OLOFSON SHOOTING RANGE
TRAINING CENTER & RANGE RENOVATION
POLK COUNTY, IOWA
PROJECT NUMBER: 16-02-77-02

September 16, 2016

This Addendum is issued to modify, explain or correct the original Drawings and Specifications, and is hereby made a part of the Contract Documents. Please attach this Addendum to the Project Manual in your possession. Insert the number and issue date of this Addendum in the blank space provided on the Proposal Form.

DRAWN BY:	PROJECT NUMBER:
CHK'D BY:	DATE:
SHEET No:	
SK-1

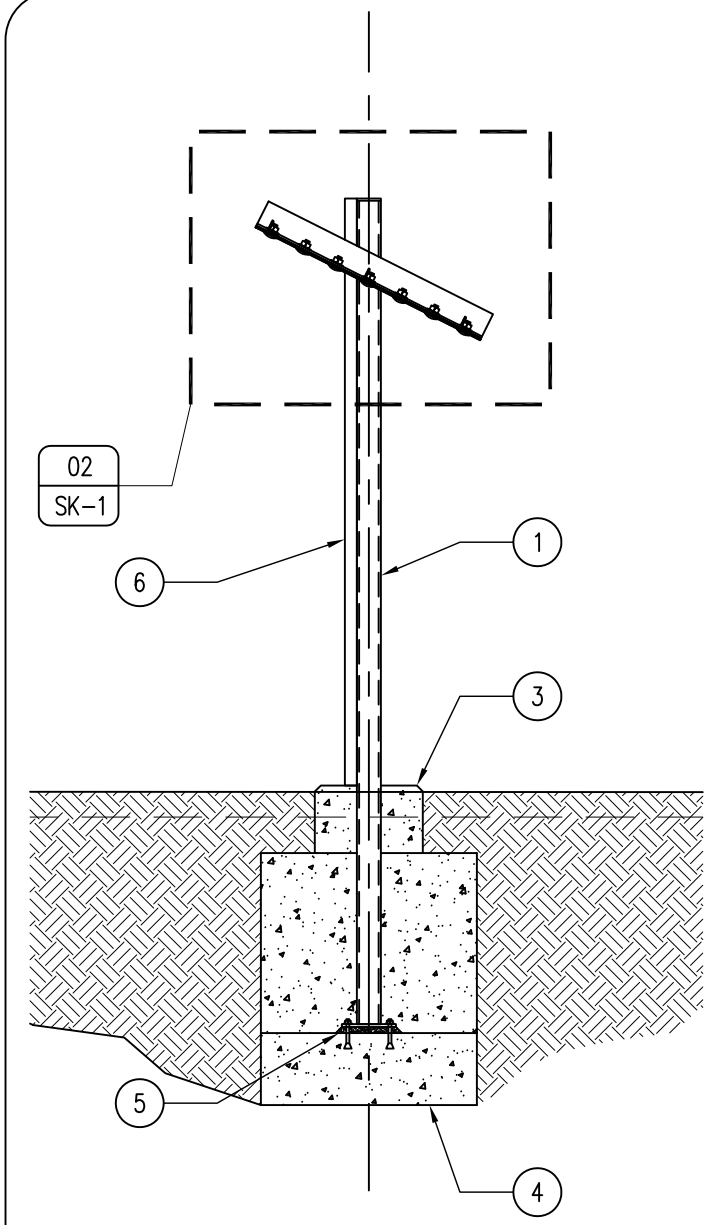
5. Range baffles are not to be adjustable, however a small 8'-0" mock-up section of a shooting lane shall be provided by the contractor for height verification prior to final approval of shop drawings.

6. The existing unistrut support for distribution panel shall be replaced.
7. Glass on exterior doors of the training center shall be insulated, double walled tempered glass.
8. Detail 02/A-311, keynote 16 on down-range baffle should be 17.
9. Detail 05/A-312 is superseded: Down-Range baffles shall be angled and supported as shown in addendum #2 sketch (see attached sketch SK-1 for more information).
10. Down-Range baffle steel spanning between columns, shall be approximately 9'-8" in length, all columns are 10'-0" center to center, field verify all dimensions prior to fabrication.
11. Bid Alternate #5 is a stone and wood entry portal, please see SK-2, SK-3 and attached modified 00300 Proposal Sheet, you must use the modified proposal form to bid this project.
